#### **Project: IEEE P802.15 Working Group for Wireless Personal Area Networks (WPANs)**

**Submission Title:** Comment resolution about Subclause 12

**Abstract:** Proposing comment resolution about subclause 12

# CSK constellation Revised Figures

# Figure 144—CSK constellation made by color band combinations

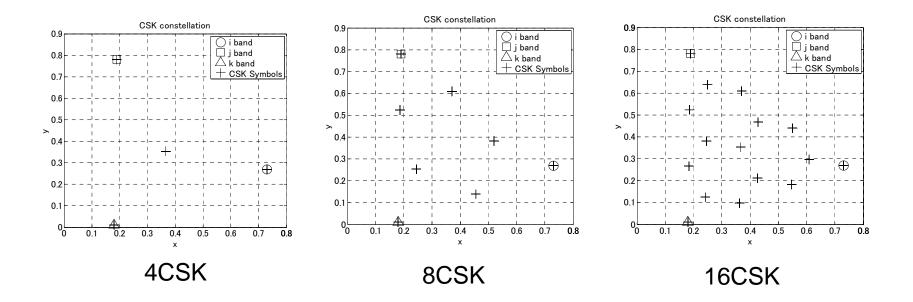
Instruction to Editor: Replace figure 144 with this figure
